**Subject: MHI's Responses to NRC's Requests for Additional Information on Advanced Accumulator for US-APWR Topical Report MUAP-07001-P, Revision 2**

**MHI's Responses to NRC's Requests  
for Additional Information**

**Advanced Accumulator for US-APWAR Topical Report  
MUAP-07001-P, Revision 2**

Fig. 33-1 Example of Distension of a Nitrogen Bubble due to Gas Expansion

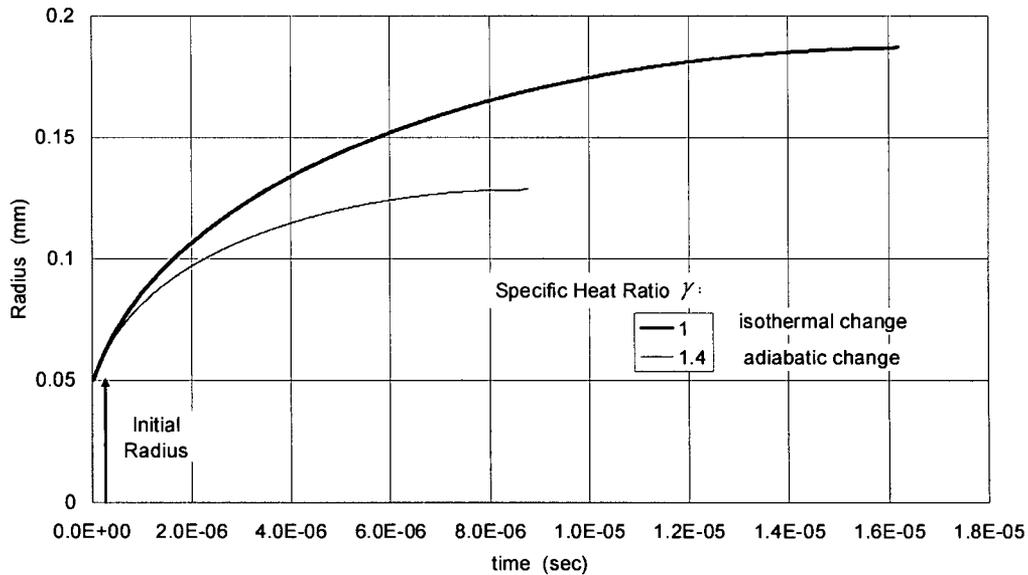
It will take time for accumulator to become saturated with nitrogen. The upper layer will saturate but thereafter, the dissolved gas will diffuse to the rest of the accumulator liquid. If there are any convection currents in the liquid, the mixing will be even faster. The response to RAI 5b dated September 2008, regarding the dissolved ratio of nitrogen in terms of diffusion period of 2 years through 10 years, does provide the actual concentration of the dissolved gas, and the dissolution of the gas as the fluid particles move to the lower pressure. The amount of gas that will evolve depends on the nucleation sites and interfacial area.

Why are the effects of nucleation sites, interfacial area density and convection not addressed, in addition to the diffusion process?

The pressure drop in the actual accumulator tank is slow. However, let's consider a nitrogen bubble that experiences abrupt depression from the storage pressure of 5.33MPa to an atmospheric pressure of 0.101MPa at time  $t=0$  sec as a stepwise to be able to examine the growth of the bubble as the most conservative. The bubble at first rapidly expands due to gas expansion, then nitrogen slowly permeates in water due to diffusion of saturated nitrogen. Bubble dynamics due to gas expansion in inviscid fluid is given by the following equation (L.D. Landau and E.M. Lifshitz: Fluid Mechanics, Pergamon Press, 1975):

The distension of a spherical bubble with an initial radius  $2 \times 10^{-3}$  in (0.05mm) due to gas expansion is shown in Figure 33-1. Surface tension on the bubble was taken into account in

the calculation. Bubble distension due to gas expansion is very rapid. For adiabatic change, or specific heat ratio  $\gamma=1.4$ , the bubble is distended in  $9 \times 10^{-6}$  sec, and for isothermal change, or  $\gamma=1.0$ , the bubble is distended in  $1.6 \times 10^{-5}$  sec. An actual bubble will be abruptly distended in time between them.

Fig. 36-1 1/2 scale Model of Flow Damper with full-height Standpipe

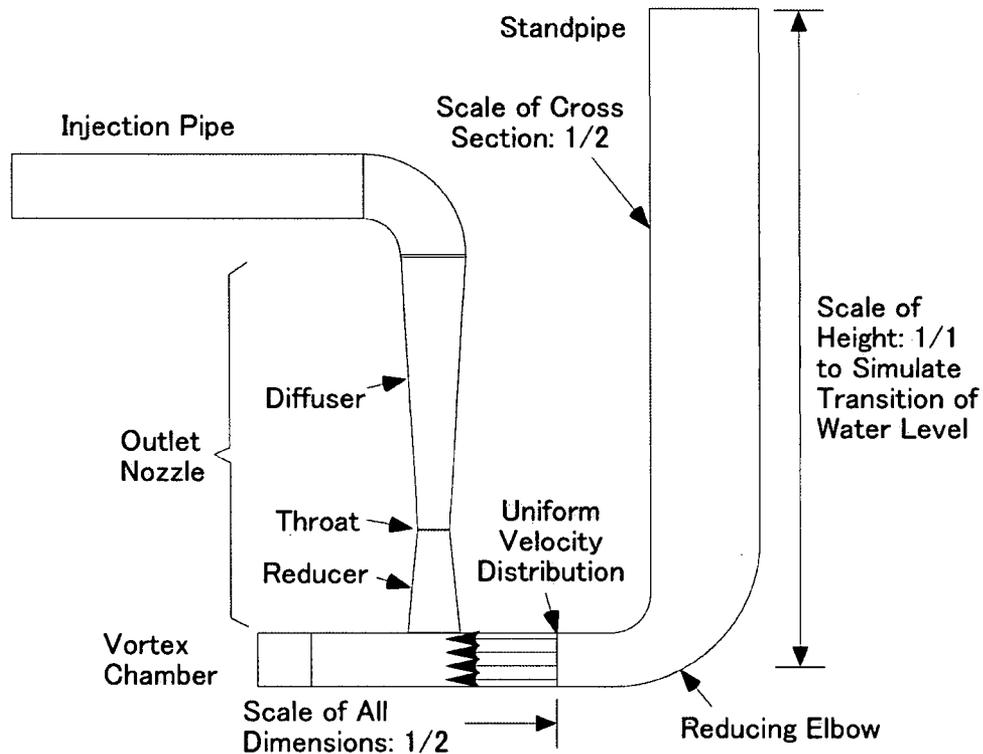
The accumulator characteristic correlations developed with the 1/2-scale accumulator test data indicate that the cavitation factor and flow rate coefficient are the only groups that represent important phenomena for high and low flow conditions.

(a) Are the cavitation factor and flow rate coefficient the only dimensionless groups that represent the important phenomena?

(b) In MHI's response to RAI 9-A (Sept, 2008), why is there no gravity term in the momentum equation? What are the boundary conditions (configuration)? What is the length scale (D) and the basis for being appropriate for all directions? Eq. 9-2 describes the local momentum balance. The statement below that Eq. states that the pressure loss is only function of Reynolds number. However, there is pressure loss beside the friction (viscous) loss that depends on the geometry. How is the pressure loss based on geometry preserved in different size facilities?

The states of flow in the full-height 1/2-scale model of the flow damper and the standpipe are shown in Fig. 36-1. The scale of all dimensions is 1/2 except the height of the standpipe. For large flow injection, the ratio of cross sectional areas of the standpipe and the large flow pipe is [ ] so that there is no flow separation in the elbow between them to make a uniform velocity distribution in the large flow pipe. In other words, the length of the standpipe does not affect the flow in the flow damper. In addition to that, the inlet of the standpipe below the anti-vortex cap is designed to have configuration without flow separation so that flow in the standpipe is uniform. The ratio of cross sectional areas of the accumulator tank and the standpipe is [ ], so the flow toward the inlet of the standpipe is rapidly accelerated for which the accumulator tank serves as a reservoir where water is almost at rest. Consequently, flow at the inlet of the standpipe is not affected by the flow conditions in the accumulator tank but only by the gas pressure. Friction losses in the standpipe for both the actual accumulator and the full-height 1/2 scale model are less than [ ] of the flow damper and negligible. Friction loss in the flow damper was evaluated with the data of 1/5 and 1/2 scale models, and the scale effect to friction loss was confirmed to be negligible for the operating conditions of the advanced accumulator. It is because the length of the flow path in the flow damper is less than that of the standpipe in addition to high Reynolds number.

(a) Generally speaking, the dimensionless groups that represent the important phenomena are the cavitation factor, flow rate coefficient, Reynolds number and Froude number. Their roles are different from each other. Reynolds number represents effect of viscosity on flow resistance. Effect of viscosity is included in the flow rate coefficient which is less dependent on Reynolds number in the plant operating conditions. Since water is isothermal, gravity affects

only the boundary conditions at the free surface of water in the accumulator tank and the standpipe, and does not appear in the momentum equation. The cavitation factor directly affects the flow rate coefficient only when cavitation occurs.

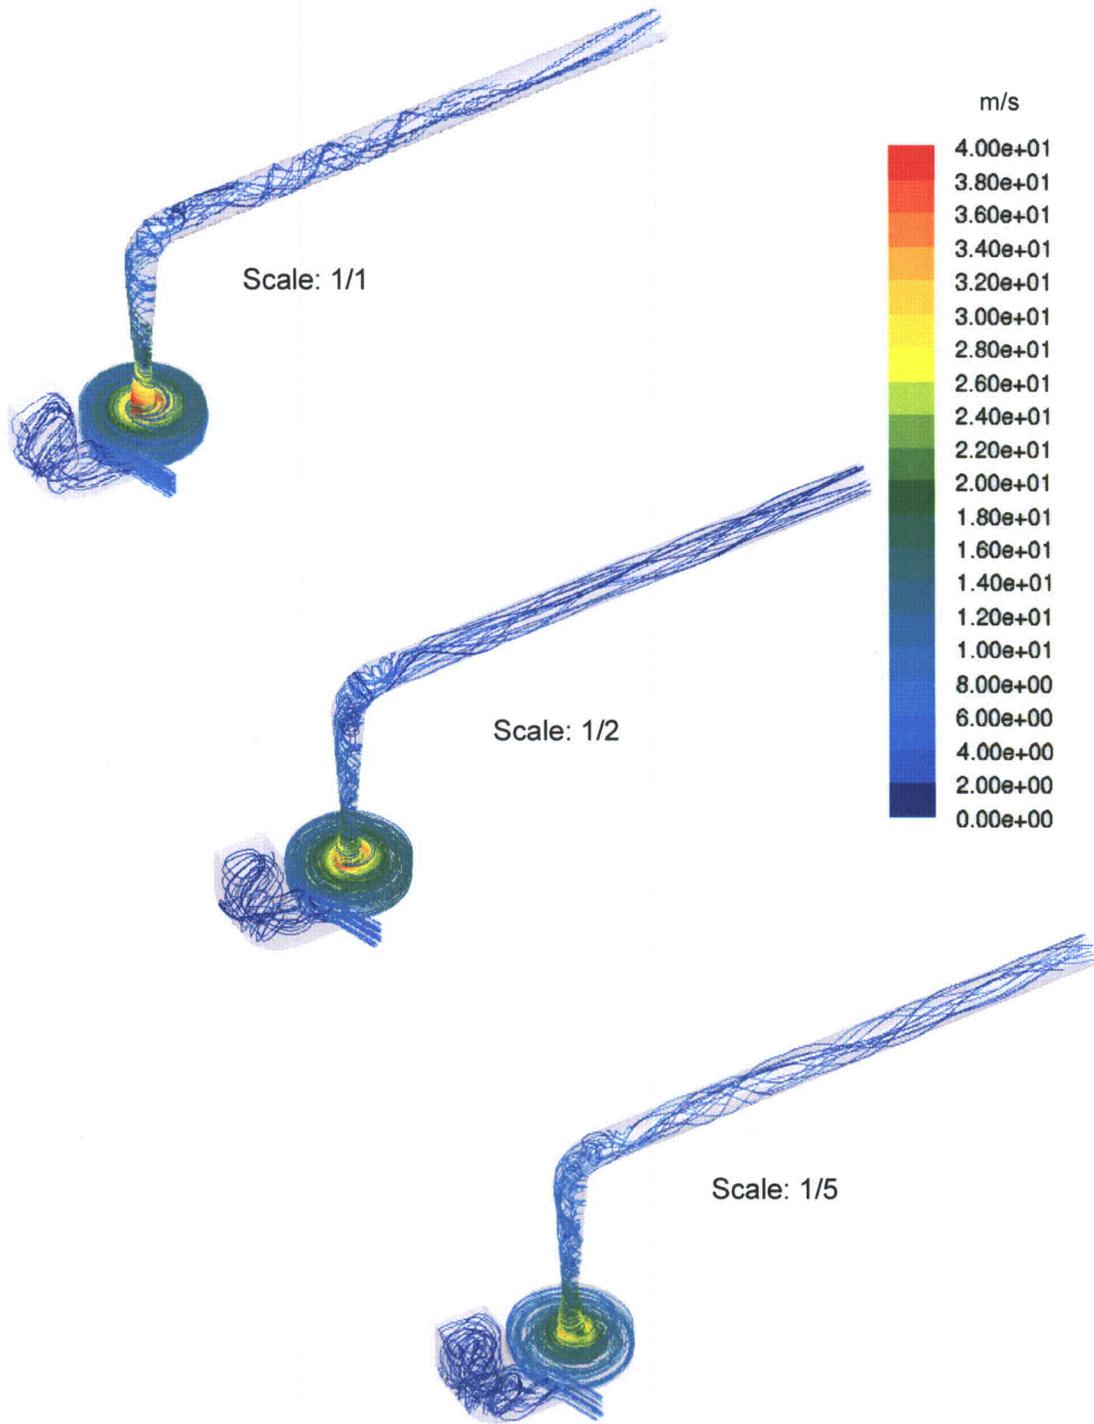
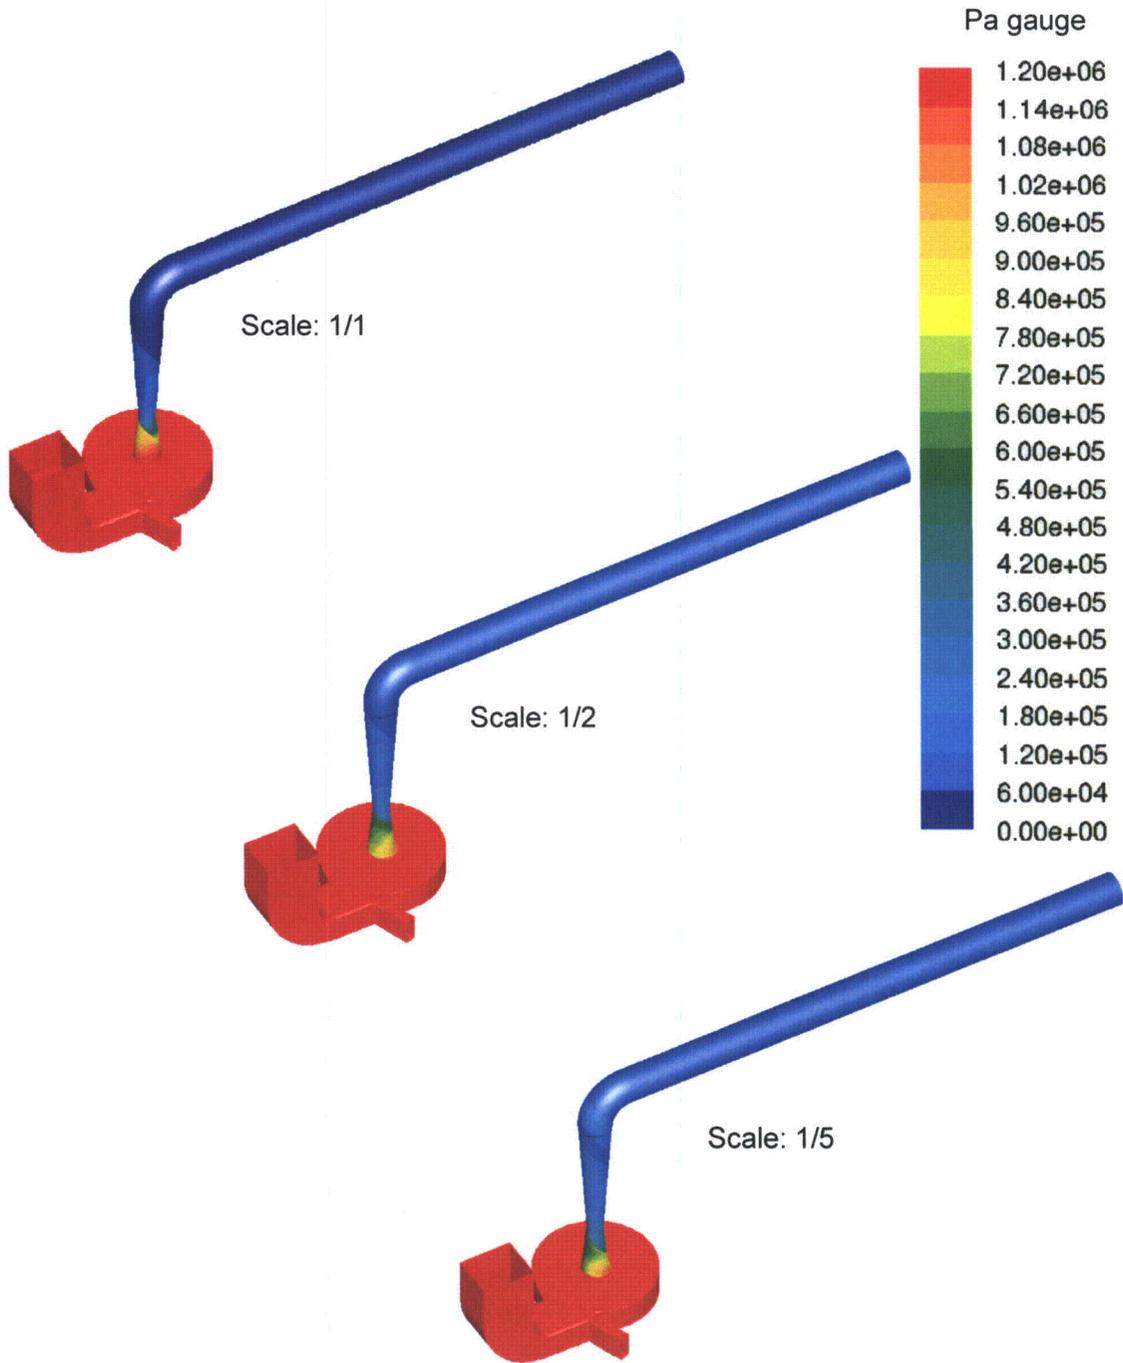
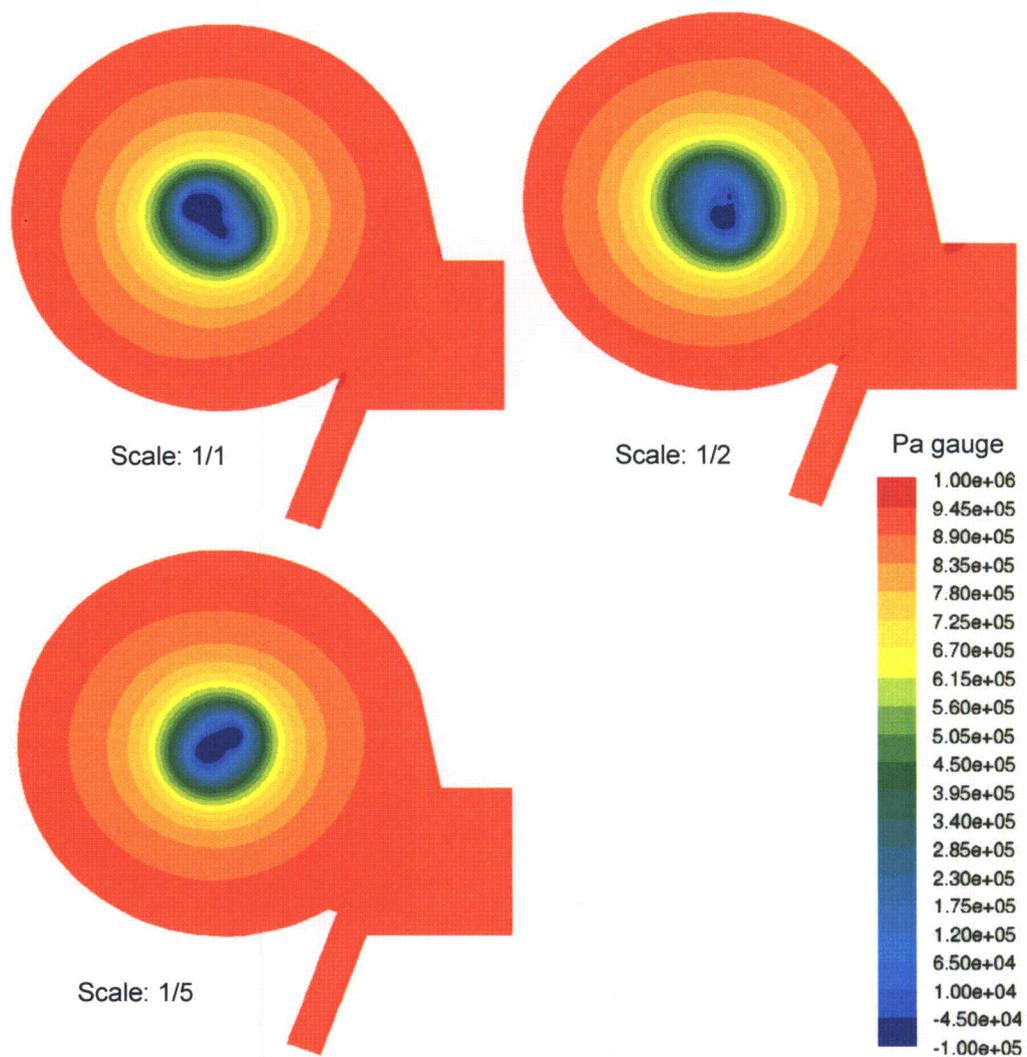
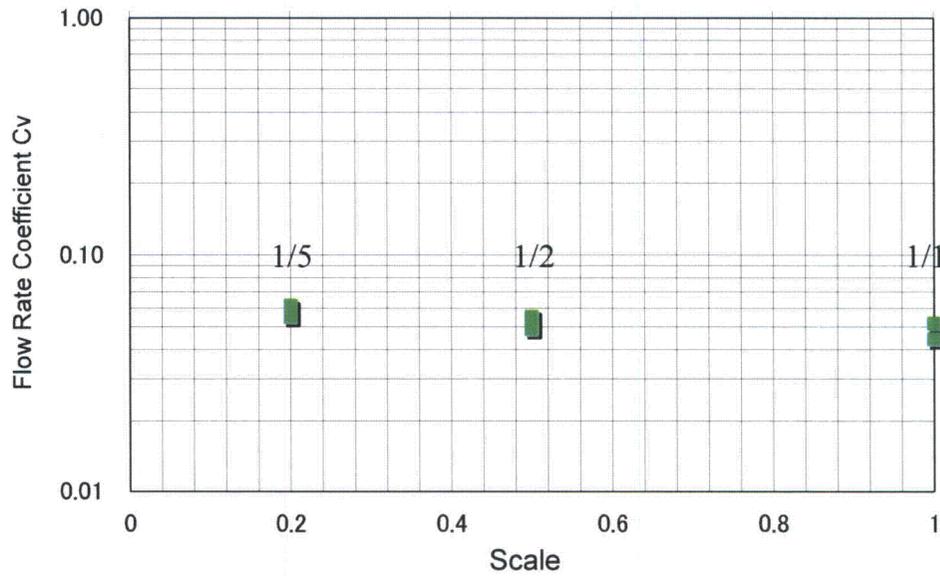
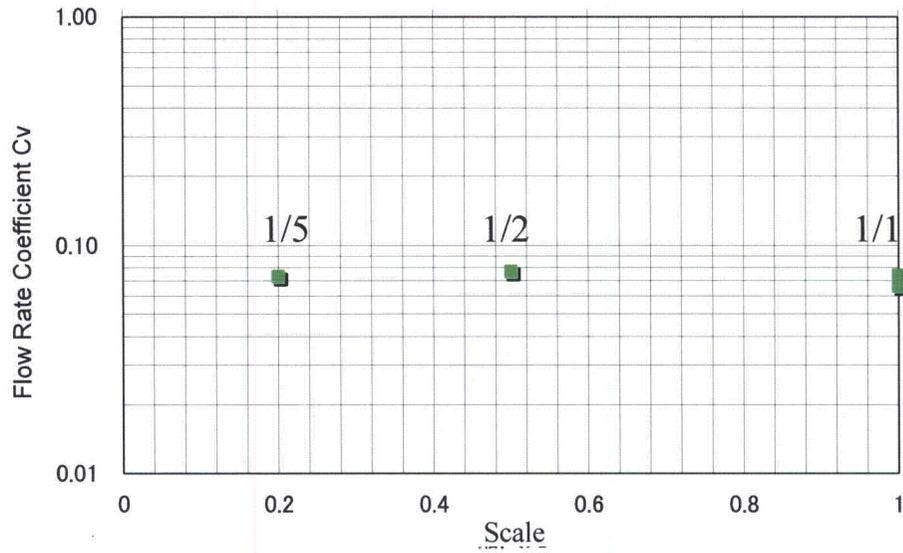
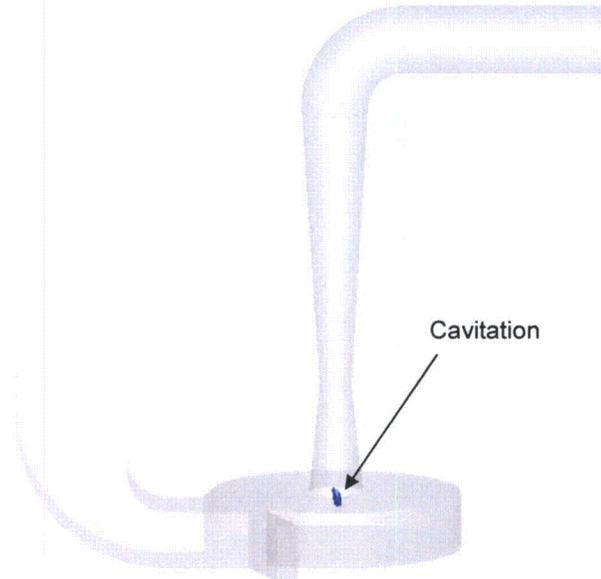
Provide any final report about the CFD calculations, including the case and data files used to make the conclusions about the flow performance map (i.e. flow rate vs. time) as well as cavitation throughout the time of performance of the accumulator during both the large flow rate and small flow rate conditions.

Figure 2 shows the flow patterns were similar to each other for 1/5- and 1/2-scale models, and the prototype.

The energy loss from the small and large flow pipes to the throat is about 90% of the total loss for all cases.

The static pressure distributions in the vortex chambers are similar to each other for all cases.

Flow rate coefficient is independent of model scale both for cavitation factor  $\sigma_v = 0.3$  and 9.4.

Cavitation may occur in the vortex chamber. Flow path surrounding the cavitation has larger area than that of the throat so that cavitation does not choke the flow rate.
